**#24-6043**

ADDRESS: 8431 Trails End Drive

## Planning and Zoning Disapproval Notice

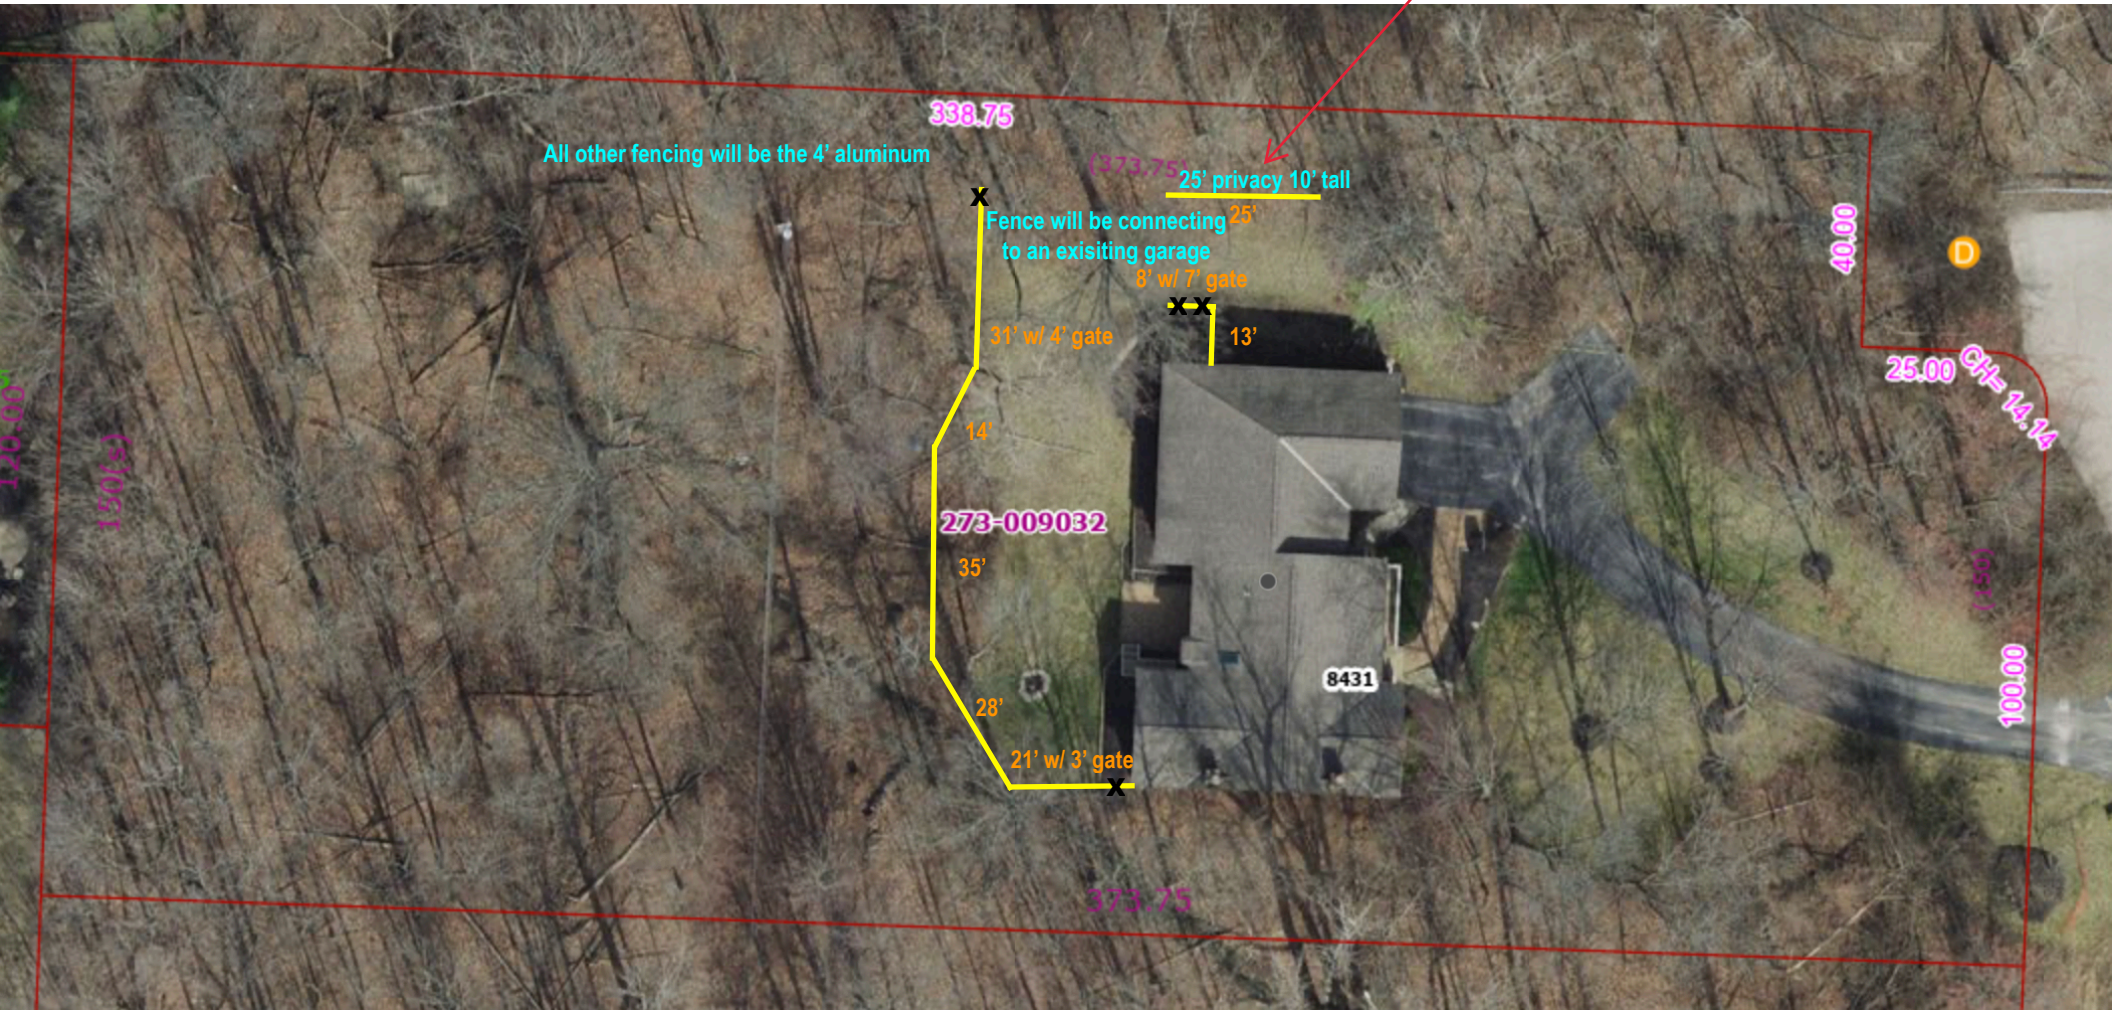
**NOT APPROVED**

Fence style and height not permitted.

**10 ft solid cedar privacy**

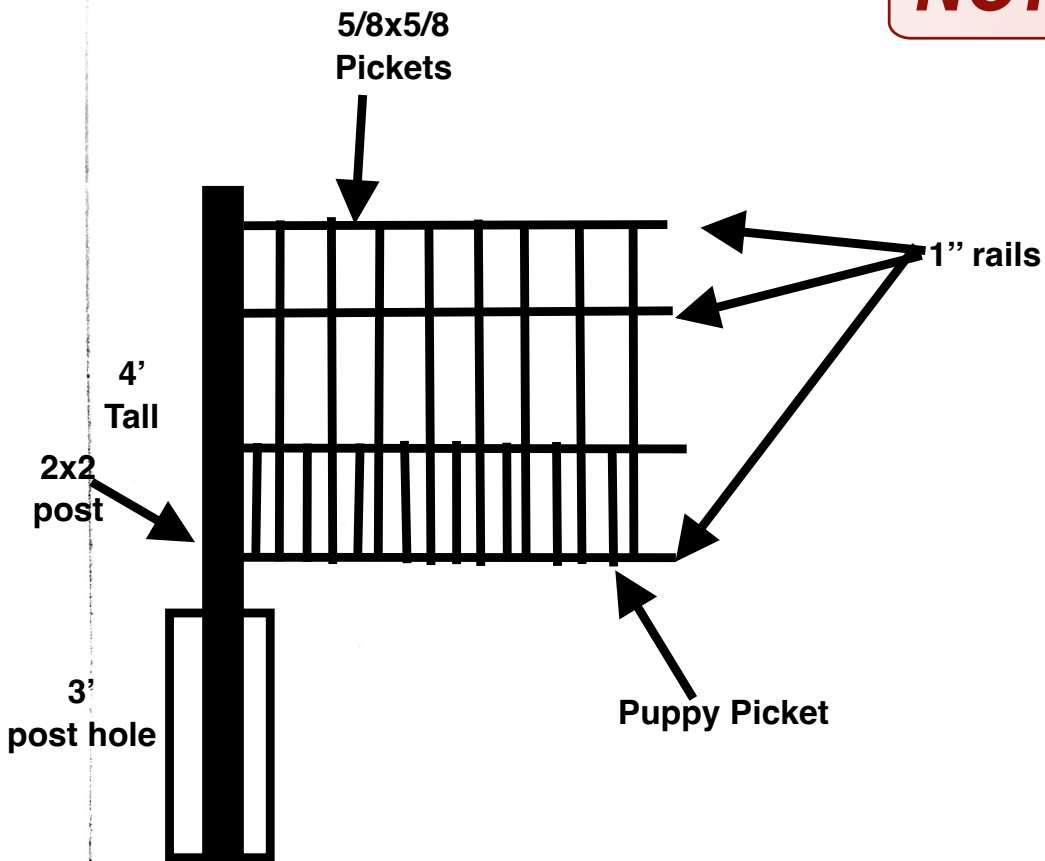
- **The proposed 10 feet tall fence is not permitted.**
  - Per Zoning Code Section 153.080 (A) *Regulations - general*. Except as otherwise specifically permitted herein, no fence or wall shall exceed four feet in height. Supporting members for wall and fences shall be located so as to not be visible from the adjoining property unless the fence is designed such that the supporting members are identical in appearance on both sides of the fence or wall. No fence or wall shall be constructed in any platted no-build zone, conservation/no disturb zone, floodway, floodplain or drainage easement for any parcel or subdivision which would be detrimental to the public health, safety and welfare. All portions of the property shall remain accessible from outside the fence area by means of a gate or other opening.

- **Proposed privacy style fence is not permitted in the proposed location.**
  - Per the Zoning Code Section 153.080 (B)(2) *Solid fences*. Solid fences shall be permitted in all zoning districts only in rear yards. Solid fences shall be no greater than four feet in height, unless otherwise permitted herein, and shall not be used to enclose the entire perimeter of the property. Such fences shall be located within the buildable area of the lot and only be used to enclose a deck or patio. Solid fences shall not be located within a required side and rear yard and shall be of an approved type. Brick, stone or masonry walls are permitted forward of the building line along scenic roadways but cannot exceed three feet in height. Fences within the front yard shall be safely placed so as not to obstruct visibility at driveway or roadway intersections.

**NOT APPROVED**

- **Please revise the materials and email all revisions and missing information to the reviewer mentioned above: [jthenderson@dublin.oh.us](mailto:jthenderson@dublin.oh.us)**
